Origination Form Proposed Revisions to a Standard Plans Index

Originator:	Turley, Joshua	Index Number:	521-611
Date:	6/5/2024	Sheet Number(s):	1
E-mail:	Joshua.Turley@dot.state.fl.us	Index Title:	CONCRETE BARRIER/JUNCTION SLAB - WALL COPING (FRP)

Sheet 1: Updated ASTM reference for GFRP dowel load transfer devices

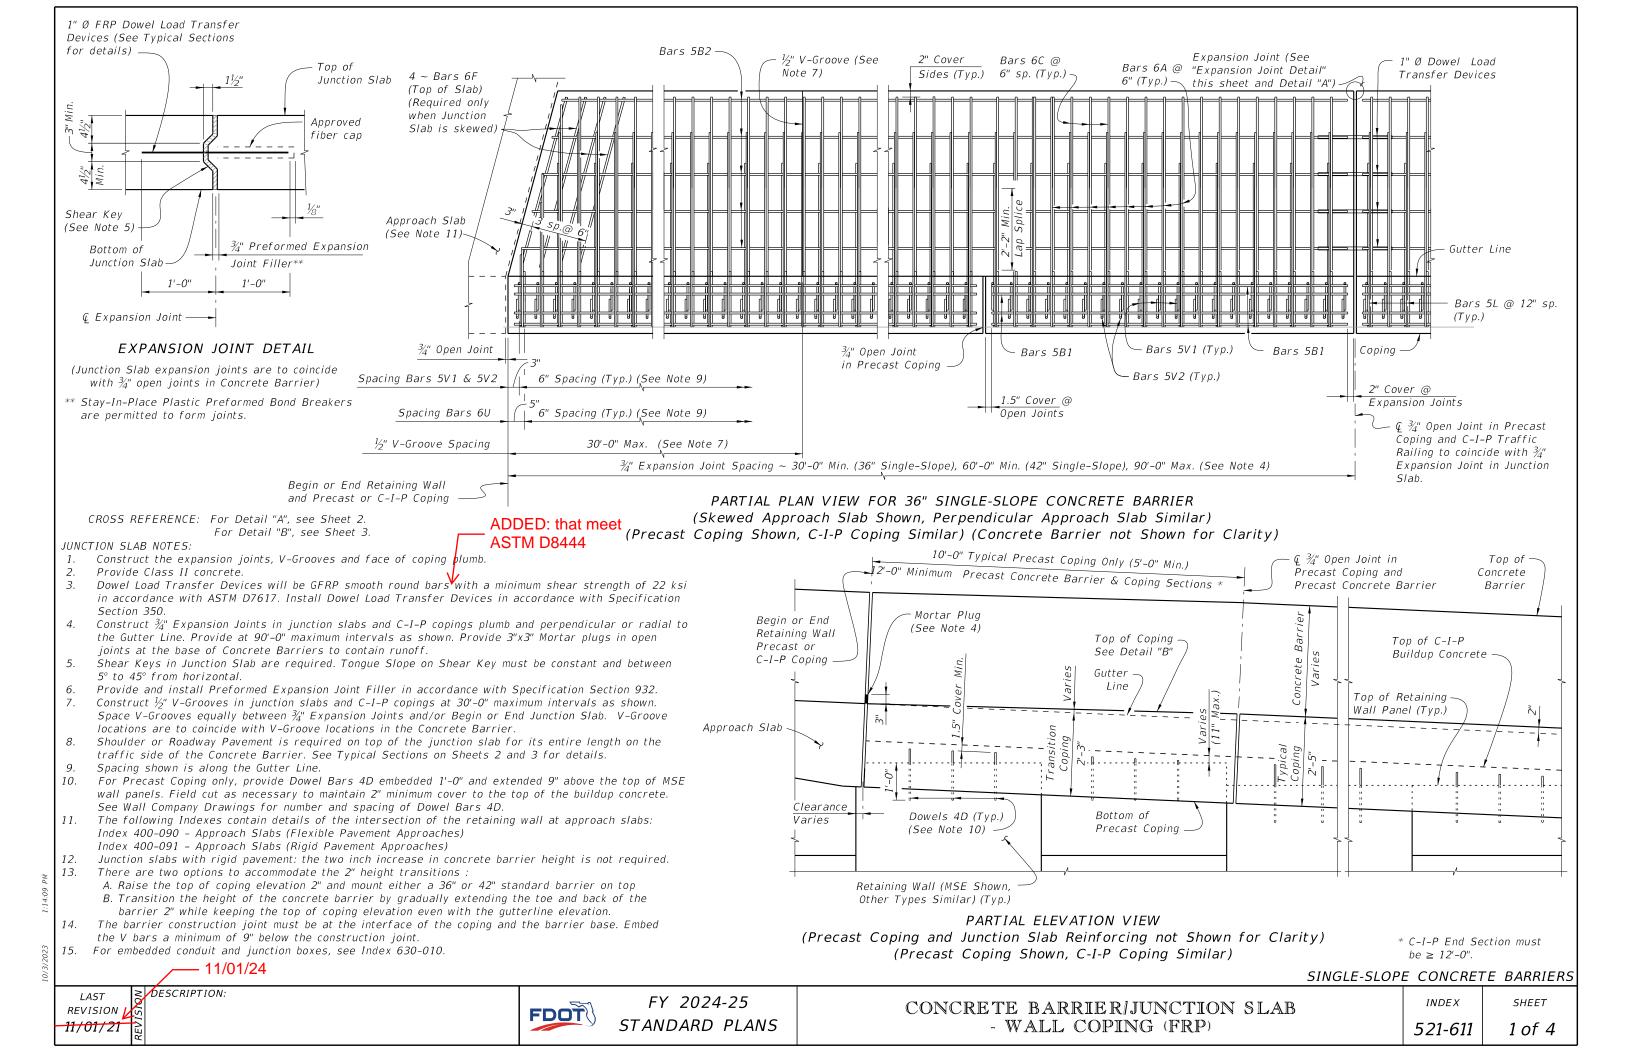
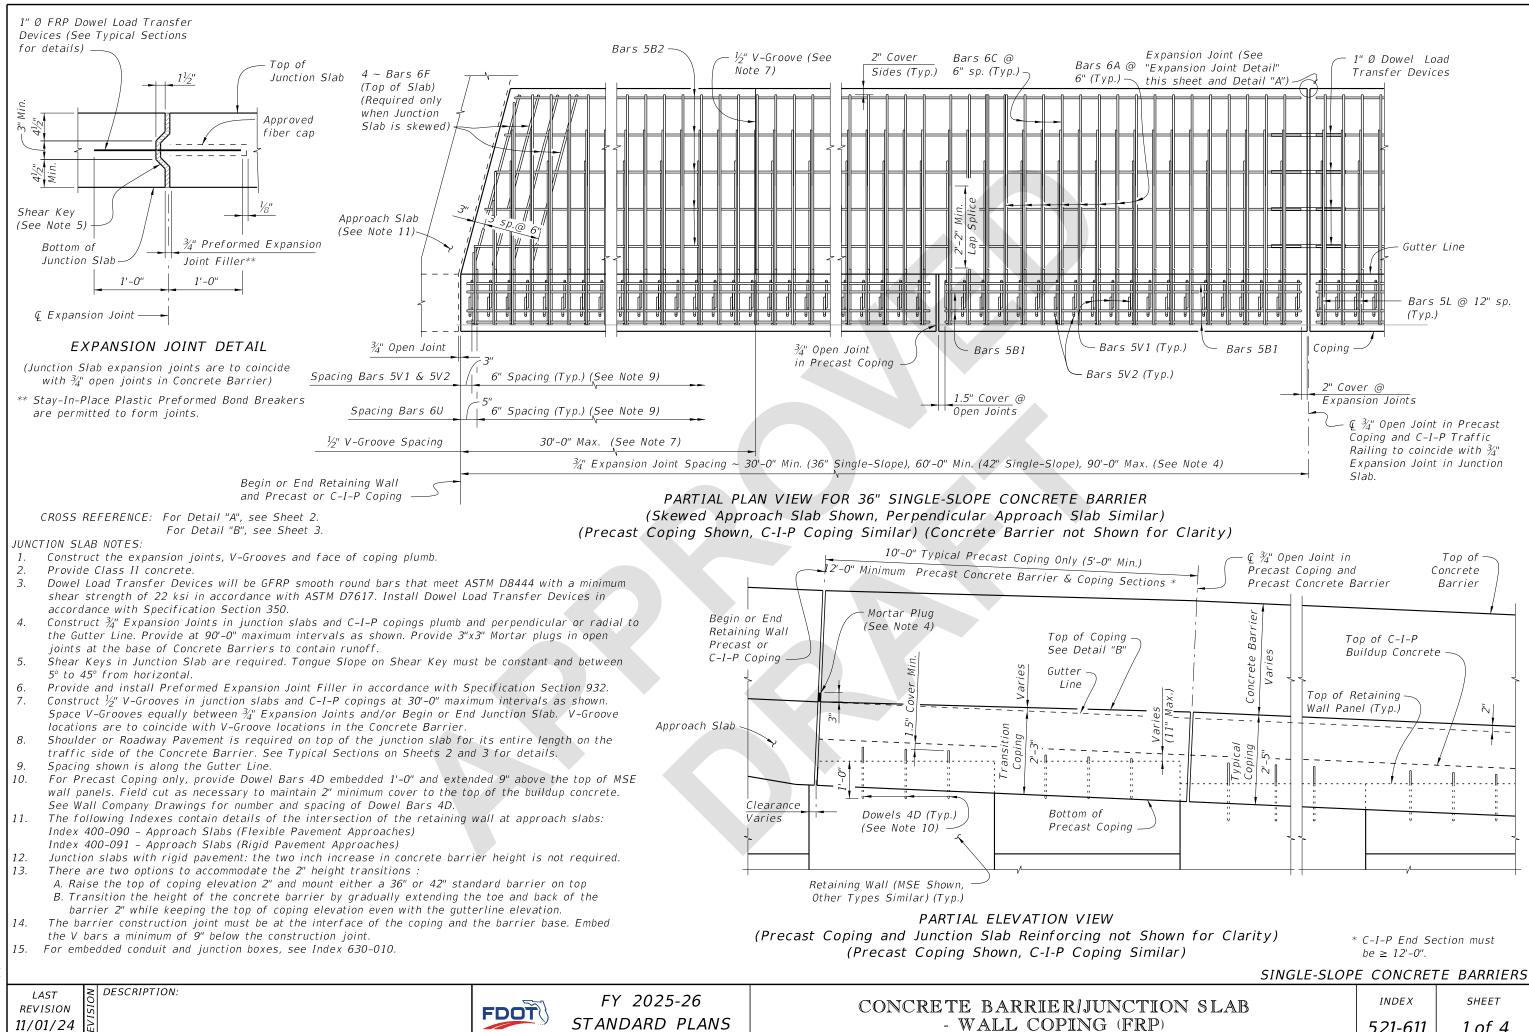
There is a updated more comprehensive ASTM that has recently been made available.
